Walla Walla Solar Farm Modification 1

Increase in solar panel height
State Significant Development Modification Assessment
(SSD 9874 MOD 1)

March 2022

Figure 4 | Development Footprint and Surrounding Receivers

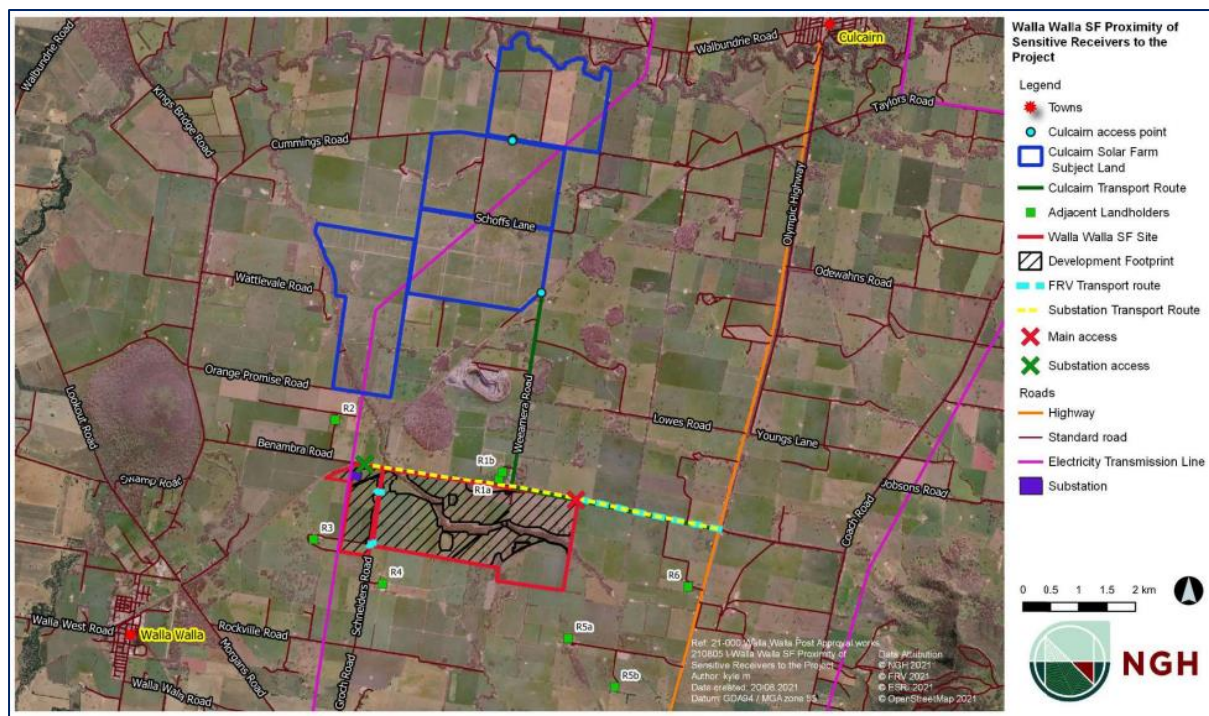
The Department's assessment of the approved project considered visual impacts from the approved project, including 4 non-associated residences (R1a, R1b and R2 and R5a) within 2 km of the project site (see **Figure 4**). The assessment concluded:

- impacts to R1 and R2 would not be significant due to the topography, existing vegetation, increased setback proposed by FRV and proposed mitigation measures (vegetation screening); and
- R5a, which operates as a wedding and function venue (Orange Grove Gardens), may experience moderate unmitigated visual impacts, noting its function room would have primary views towards the solar farm, but that these impacts that would be substantially mitigated by an increased setback proposed by FRV, and vegetation screening.

The Department acknowledges submissions expressed concern about the visual impacts of the taller panels. An Addendum VIA was undertaken as part of the Modification Report, focusing on the incremental visual impacts of the changes to solar panel and transmission tower heights at Receivers R1, R2 and R5. The Addendum VIA concluded:

- the increase in solar panel height would result in a small increase in the visibility of the project at R1, but these incremental impacts would be minor;
- the change in panel height would not result in a higher residual visual impact for R2 and R5 with the implementation of the proposed mitigation measures; and
- the increase to the substation transmission tower infrastructure is expected to result in a small increase in visibility for R2, although this impact would not result in a higher residual visual impact.
